ADDENDUM NO. 5

**FINAL CLOSURE CONSTRUCTION IMPROVEMENTS
AT THE COLTON SANITARY LANDFILL**

JUNE 22, 2022

FIGURE 1

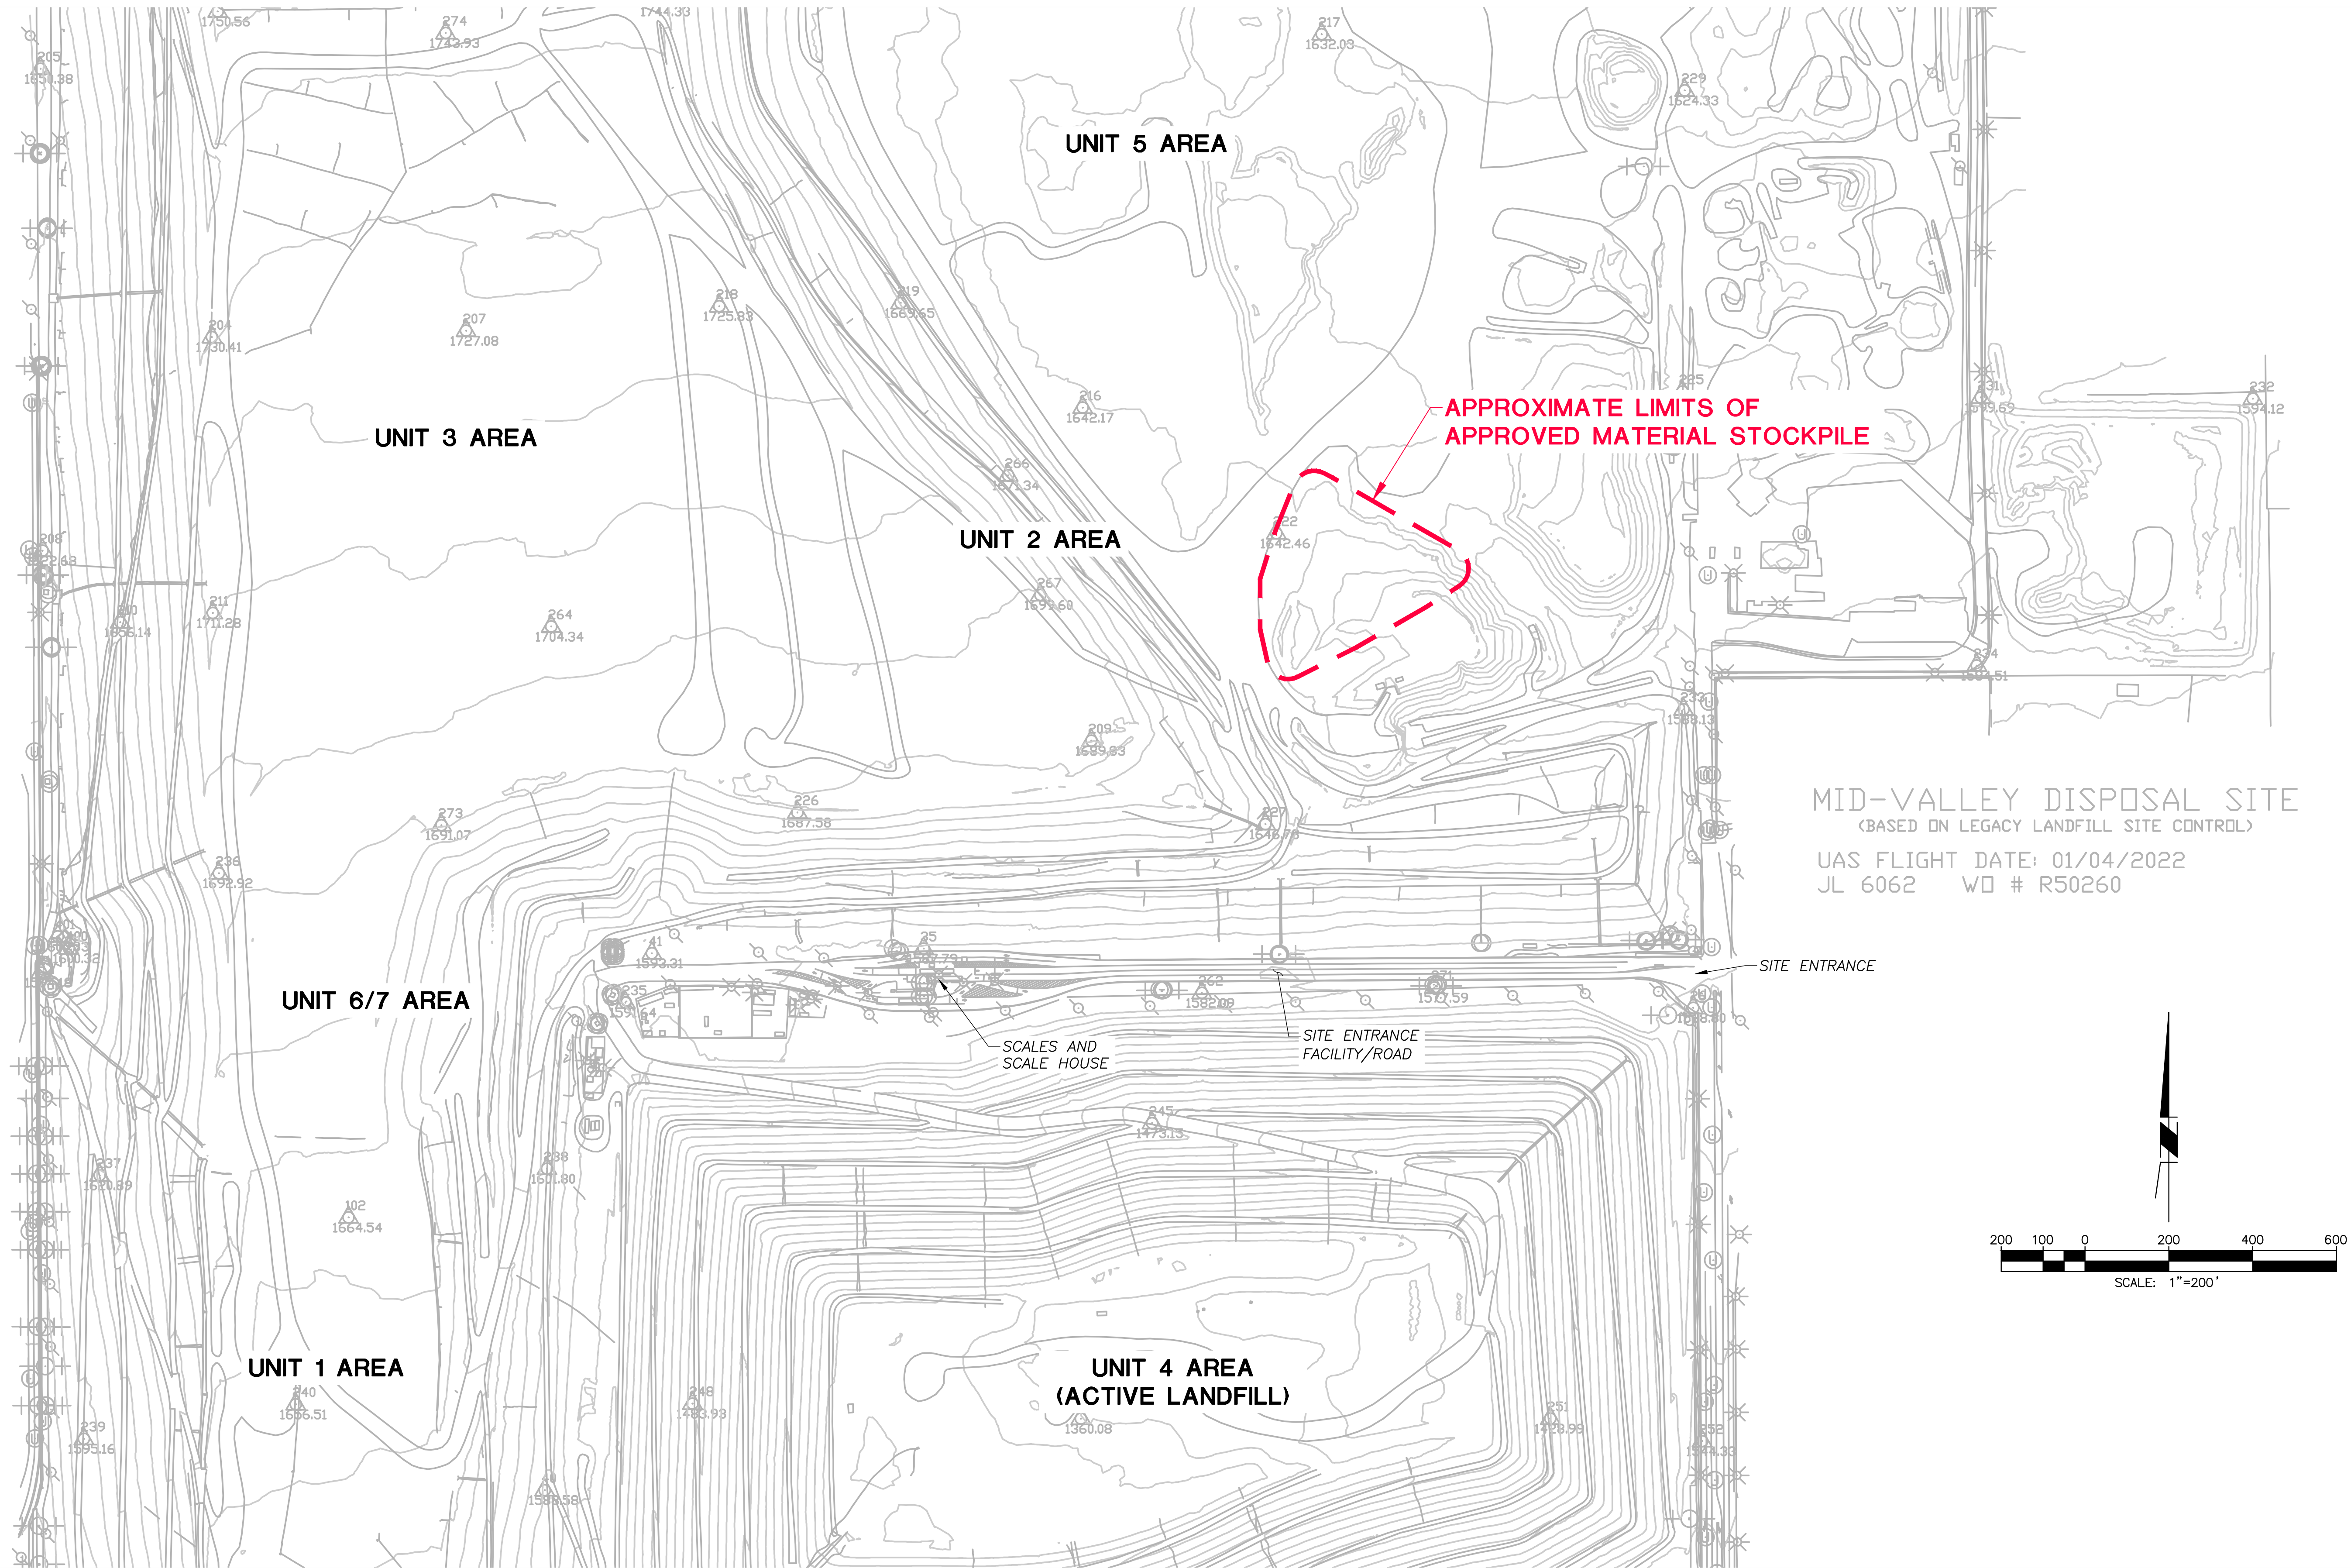
- I. A source for import material is available at the Mid-Valley Landfill. "SWMD has identified an Approved Source for Import Material (described in the Project Technical Specifications Section 2D 2.1.2) located at the San Bernardino County owned Mid-Valley Sanitary Landfill (2390 Alder Ave, Rialto, CA 92377). The Import source is approximately 12-16 miles away from the Colton Sanitary Landfill. The attached Figure 1 shows the approximate location of the material stockpile at the Mid-Valley Landfill.

There will be no cost associated with purchasing the dirt from San Bernardino County. Import/export operations at the Mid-Valley Landfill must occur during regular business hours Monday-Friday 7:00AM-5:00PM". Contractor will be responsible for loading, hauling, and screening to remove cobbles/rocks that are 4" and larger.

LiteEarth Pressure Relief Valve Design

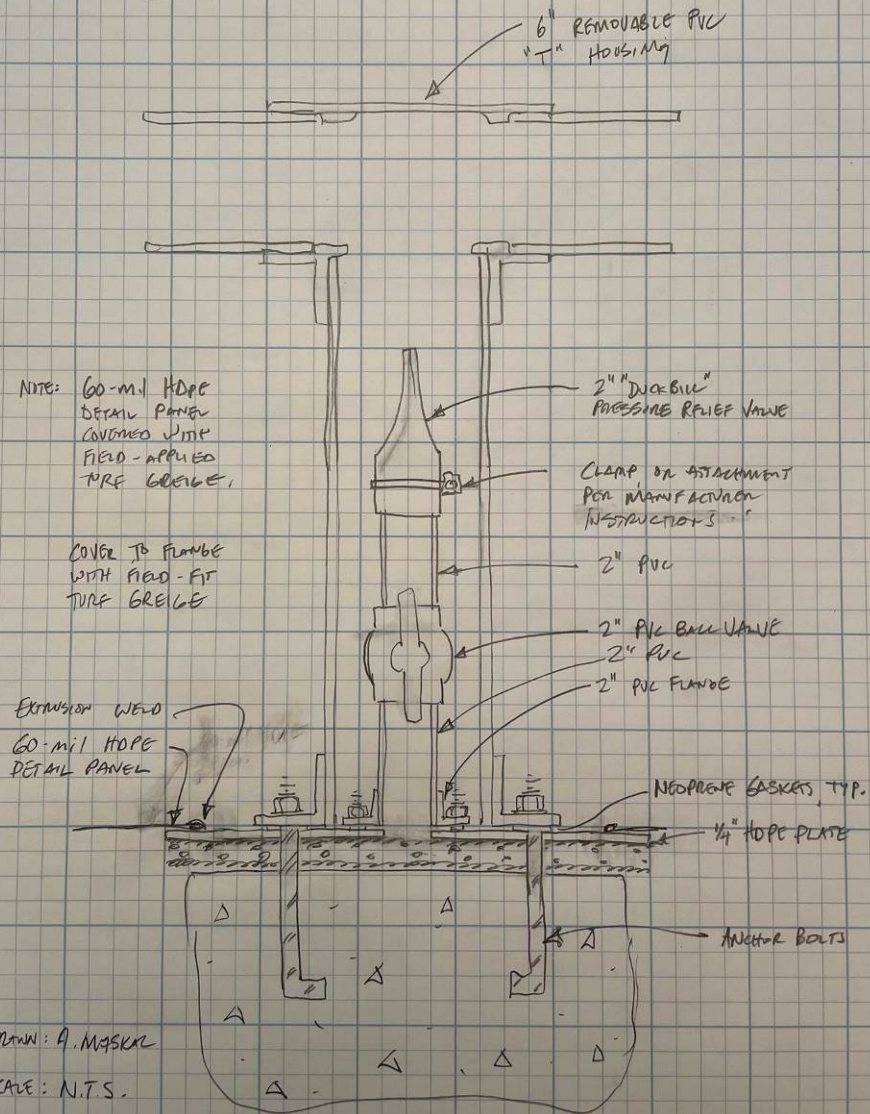
Q23. Pressure Relief Valves are proprietary to the ClosureTurf technology. Please provide the equivalent product or a design of a relief valve for the Lite-Earth system. (Ref Area: LFG Bid Item G17 – Pressure Relief Valve per Detail 6/GD14 and Section 2.1 – Passive Pressure Relief Valves)

A23. See attached LiteEarth Pressure Relief Valve Design. Alternative “B” pressure relief valves will be incidental to the Square Footage bid items for the geosynthetics – Bid Items No. 9A and 9B.

Figure 1 Site plan view, screenshot from CAD

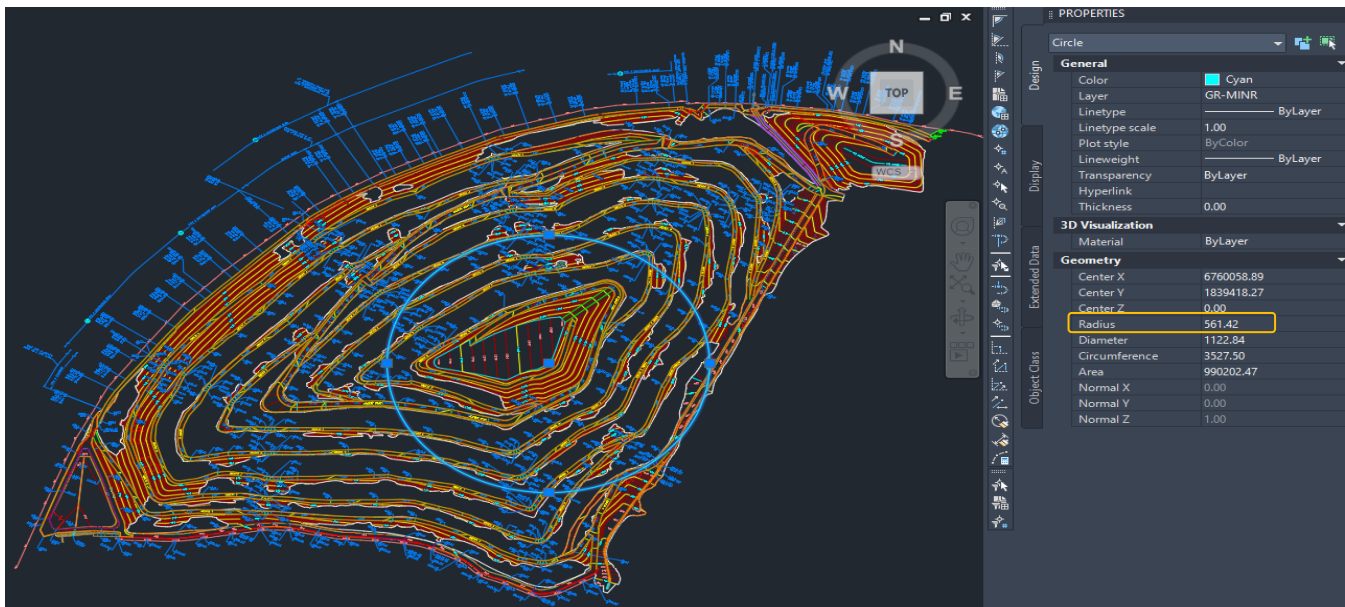
Q47. Can the engineer provide the required spacing on the Platipus Anchors required for Option B?

A47. See attached grid design for required spacing of Platipus Anchors.
